# Value Engineering Study **US-6, Wadsworth Interchange** CDOT Project ES6 006A-047 (17858)

Prepared for  
**Colorado**  
Department of Transportation

Prepared by  
**CH2MHILL®**

Final Report Date: July 30, 2013

Figure B1-2: Single Span Bridge with Box Culverts on Either Side for Multi-Modal Access

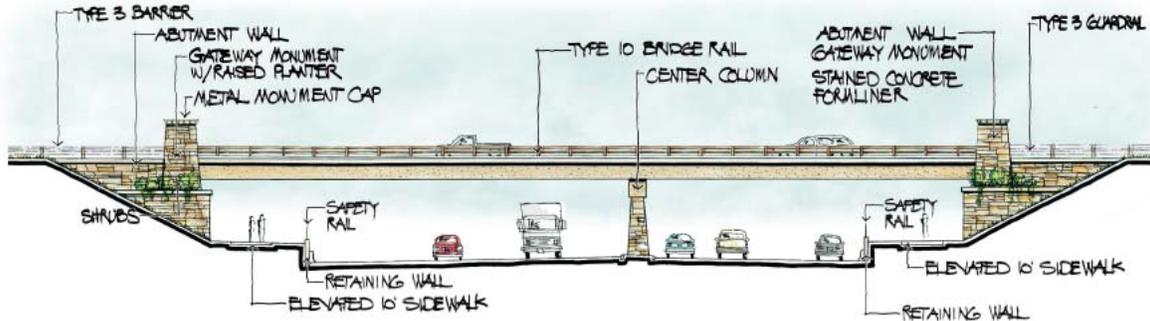
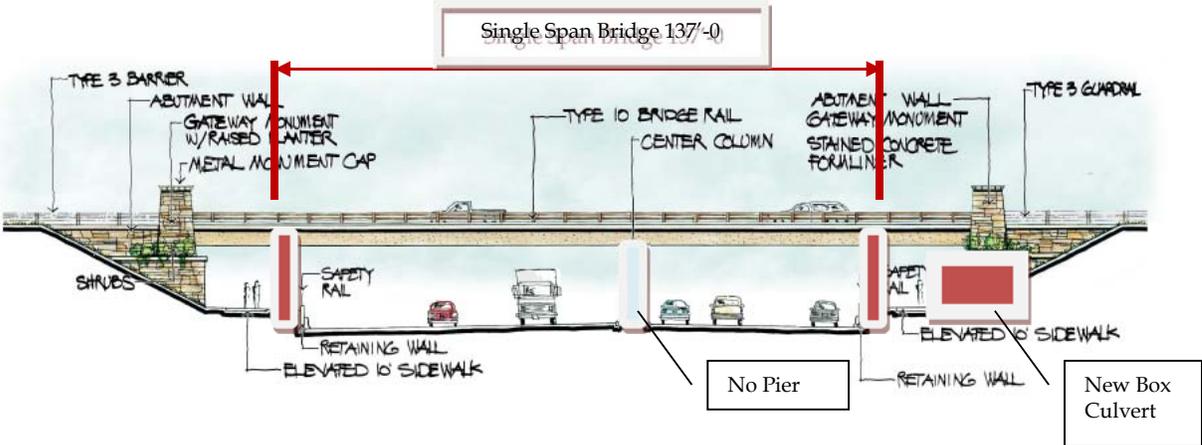
The new bridge layout was developed based on the assumption of accommodating both pedestrians and bicycle traffic on both sides of Wadsworth Blvd. This multi-modal path width is about 23 ft on each side, and the corresponding bridge length is 248'-6". Refer to Figure B1-1 below, provided by the design team.

The VE team proposes to eliminate the multi-modal path on both sides and use a box culvert for pedestrians and bicycle traffic on one side only. This will shorten the bridge since we do not have to extend the span to cover the multi-modal paths shown. This proposal allows the use of box culverts on both sides to accommodate the pedestrians. In this configuration the center piers can be omitted and the bridge can be converted to a single span. Refer to Figure B1-2 below.

Figure B4-2: VE Proposal for Shorter Bridge with One Pedestrian Path on East Side of Wadsworth under the Bridge

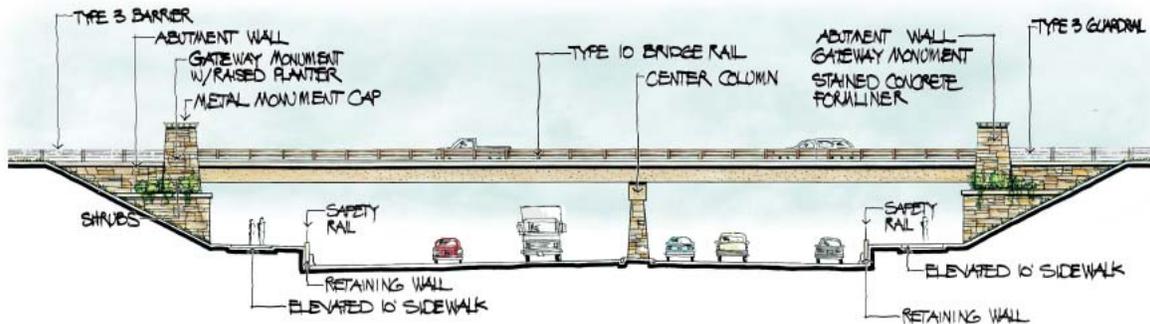
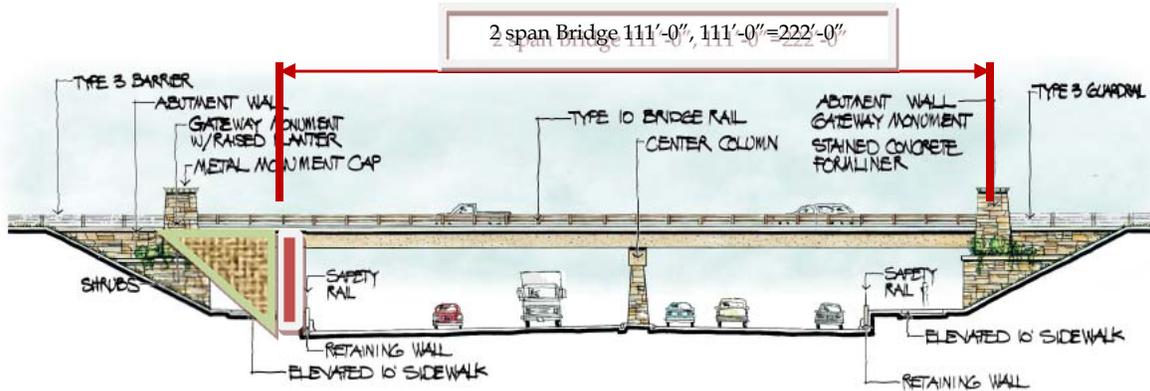
The new bridge layout was developed based on the assumption of accommodating both pedestrians and bicycle traffic on both sides of Wadsworth. This multimodal path width is about 23 ft on each side and the corresponding bridge length is 248'-6". Refer to Figure B4-1.

The VE team proposes to eliminate the multimodal path on the West side and maintain what is originally proposed on the east side for pedestrians and bicycle traffic. This will shorten the bridge since we do not have to extend the span to cover the multi-modal path on the west side. Refer to Figure B4-2.

Figure \_B5-2.

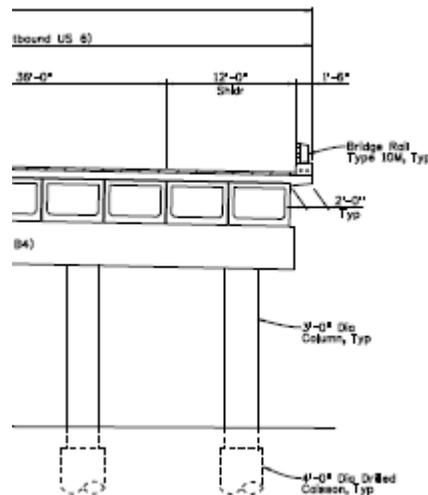
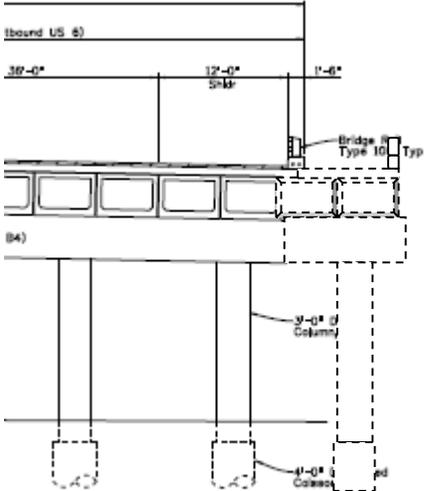
The proposed bridge layout was developed based on the assumption of accommodating 3- (three) traffic lanes in both directions on 6<sup>th</sup> avenue. The current cross section width is 130.5 ft.

The VE team proposes to add one more traffic lane in each direction on 6<sup>th</sup> avenue resulting in an additional 24 ft to the width proposed by the design team.

The Value Engineering team recommends this proposal for further consideration. This proposal provides additional area for potential widening in the future and eliminates the need for a temporary bridge. This will also provide additional area for emergency pull outs, and for snow storage.
